## Product Change Notification

**1. ECR #:** 163073  
**Notification #:** 325

- SEAF - .050 PITCH SOCKET ARRAY ASSEMBLY

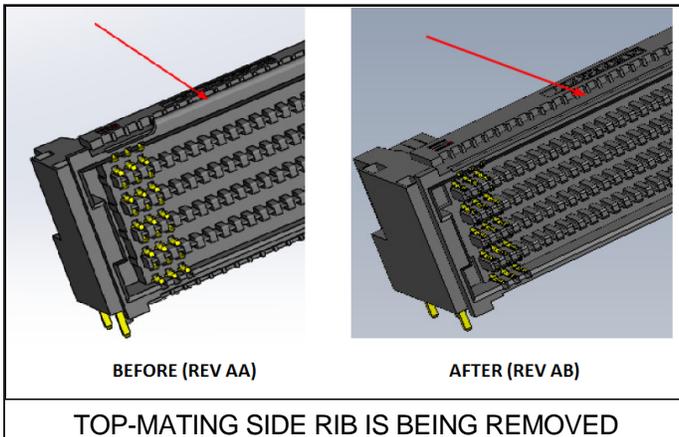
**5. Description of Change:**  
Top-Mating side rib added on revision AA is being removed.

The rib, shown below, will be removed with this revision. The change is visible at the top/mating side of the connector.

This is a form change. This rib was added to SEAF-RA for use with a cable project and has been in place for the past 6 months. SEAF-RA will have the same fit and function without the rib. The rib was added in preparation for a standard product cable project, but is no longer needed. The added rib did increase interference with SEAM-ELEVATED (SEAM-XX-06.5-XX-XX-X-A-XX-K-TR, SEAM-XX-07.0-XX-XX-X-A-XX-K-TR, SEAM-XX-09.0-XX-XX-X-A-XX-K-TR, SEAM-XX-11.0-XX-XX-X-A-XX-K-TR, & SEAM-XX-13.0-XX-XX-X-A-XX-K-TR) and is being removed. Please contact Samtec if your application requires mating SEAF-RA with SEAM-ELEVATED. This will be a rolling change.

- Form - RIB IS BEING REMOVED
